0.0 TECHNICAL MEMO – Turbidity and Coastal Processes

To:	Stacey Sharp & Blair Masefield, Beca (consultant planners)
From:	Dr Doug Treloar, Senior Principal Coastal Engineer, Stantec
Ref:	Northland Regional Council: APP.005055.38.01 Whangārei District Council: LU2200107
Date:	16 November 2023

The purpose of this supplementary memorandum is to respond to technical matters pertaining to coastal processes monitoring conditions, dredge turbidity management conditions and the adequacy of the coastal modelling that were raised during initial hearings proceedings.

Annexure A

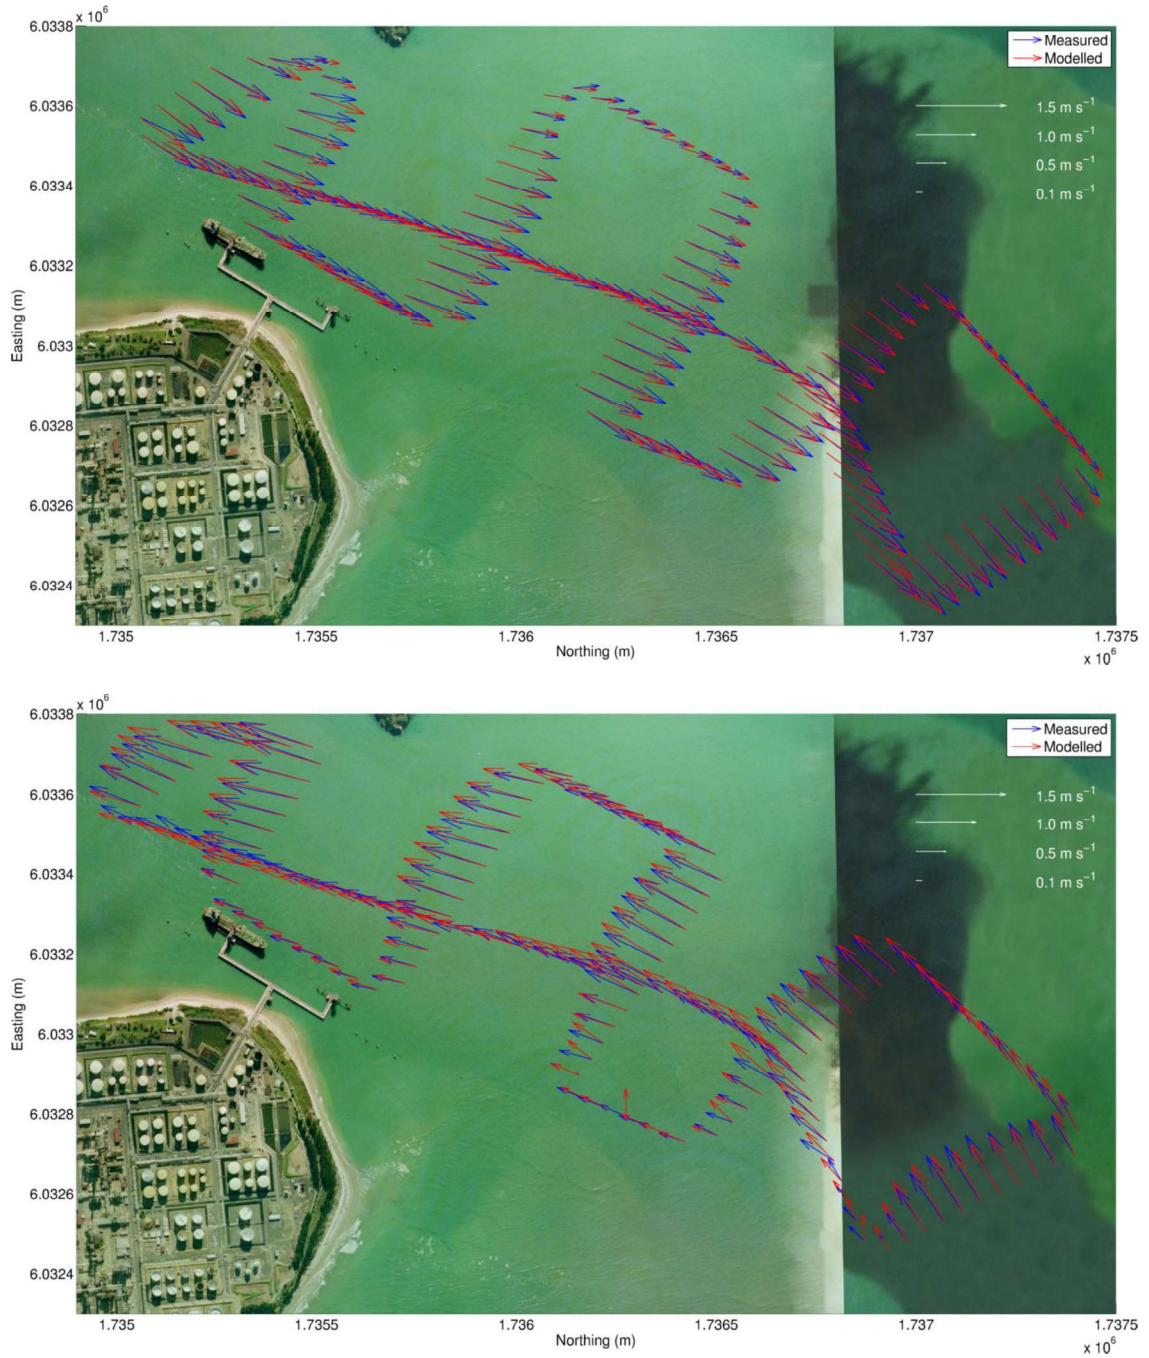
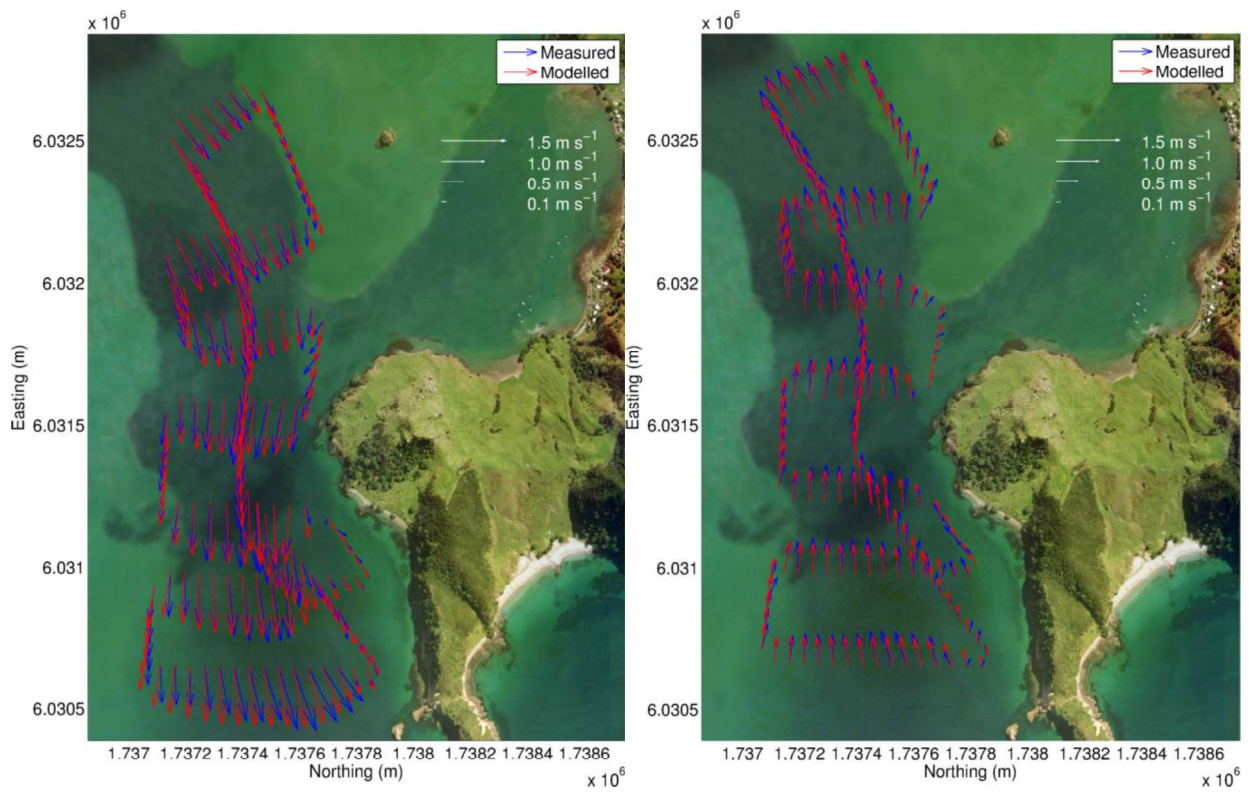
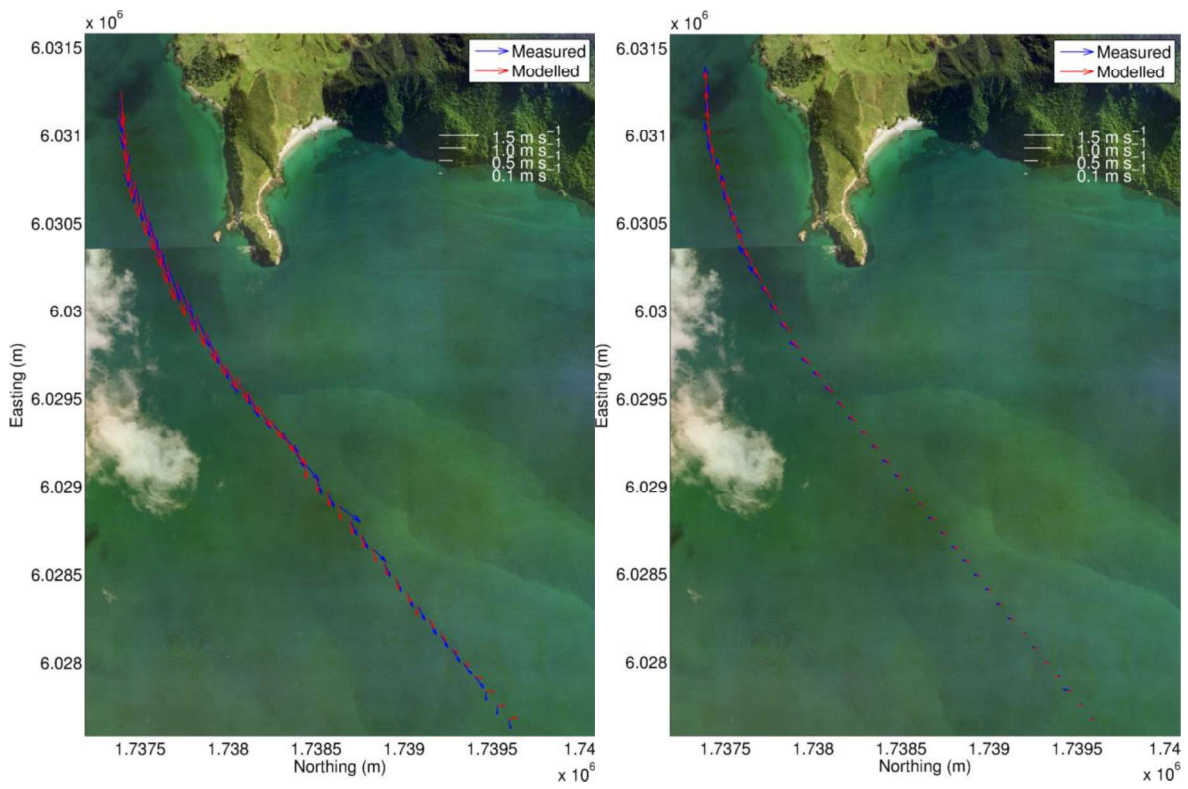
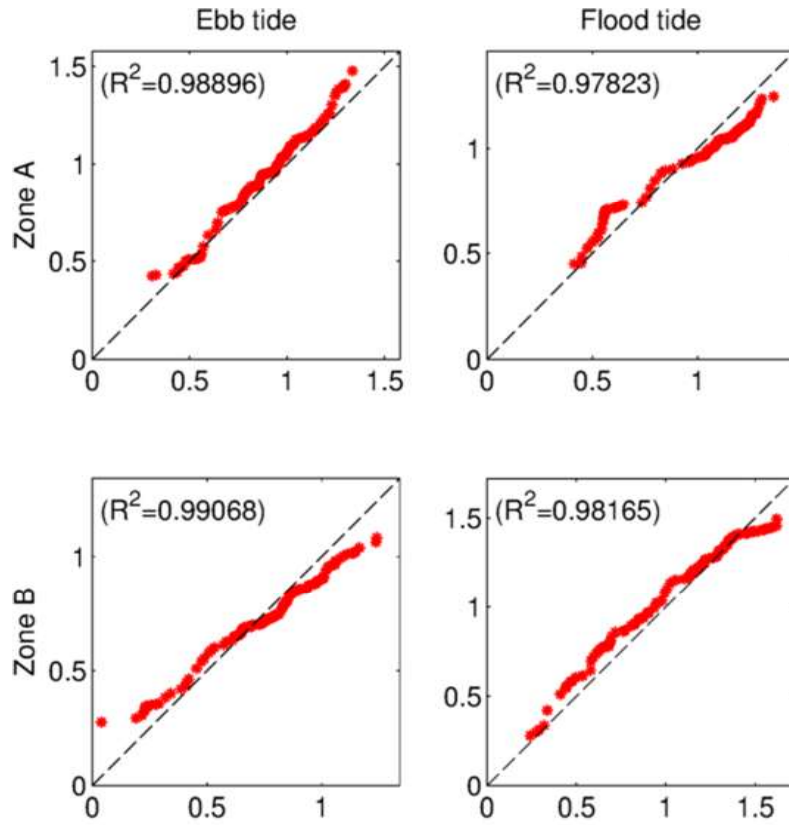
Annexure A has been taken from MOS's report No 2, and describes the measured current and modelled data in terms of vectors – arrows that describe current direction and speed, the latter by the length of the arrows. Measured data is in blue and the modelled data is in red. There are both flood and ebb results. The fact that there is good agreement across and along the channel confirms that the model is reliable.

It is agreed that longer current records are used often, but they are generally at single points, or a few of them, and do not provide the same spatial model confidence.

Figure 3.11 Measured (top) and model (bottom) depth change after one year from 2016 to 2017.

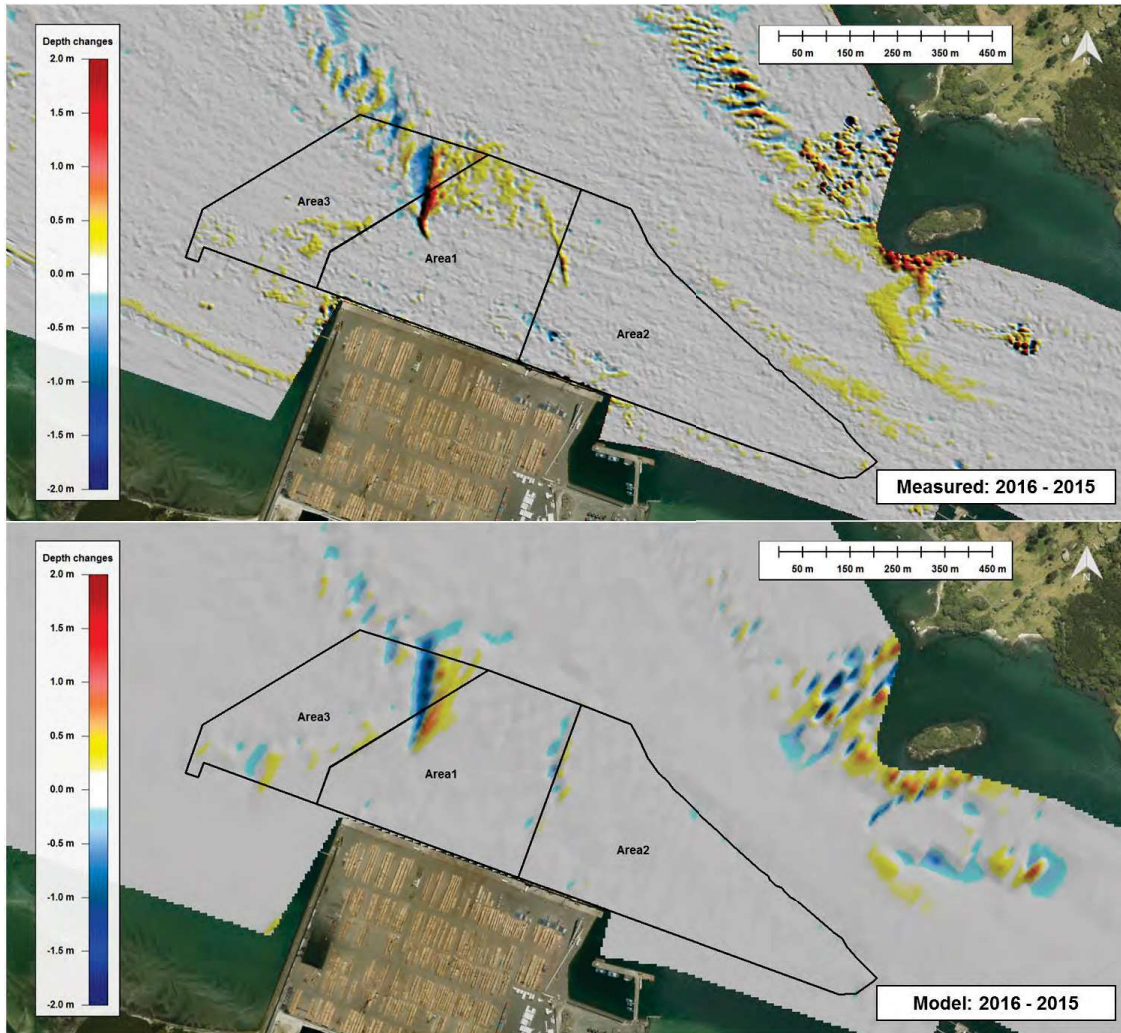
MOS's report No. 1, cited above, does describe MOS's validation of the sediment transport and erosion/deposition processes near Marsden Point. Model validation was undertaken against reliable hydrographic survey differences that described the changes in the seabed levels near Marsden Point caused by the presence of the existing dredged seabed and the regional coastal processes – currents, waves, bed form and sediment characteristics. Their morphological modelling results are presented in their report Section 3.5 and their Table 3-3, which summarises their validation modelling results for the period 2016 to 2017, for which there was reliable seabed survey – see **Annexure B**.

The good outcome of the morphological modelling could only have been achieved if the hydrodynamics of the model were physically realistic, because without realistic currents and other data it would not be possible to achieve good morphological results. In this context, I say that good, albeit subjective, is a realistic assessment because the results of the morphological modelling presented in MOS's Table 3-3 are within 10% on a total volume change basis; noting that individual cells selected by MOS have larger differences. The overall character of the changes, with sediment moving seaward from Snake Bank is in agreement with observations.
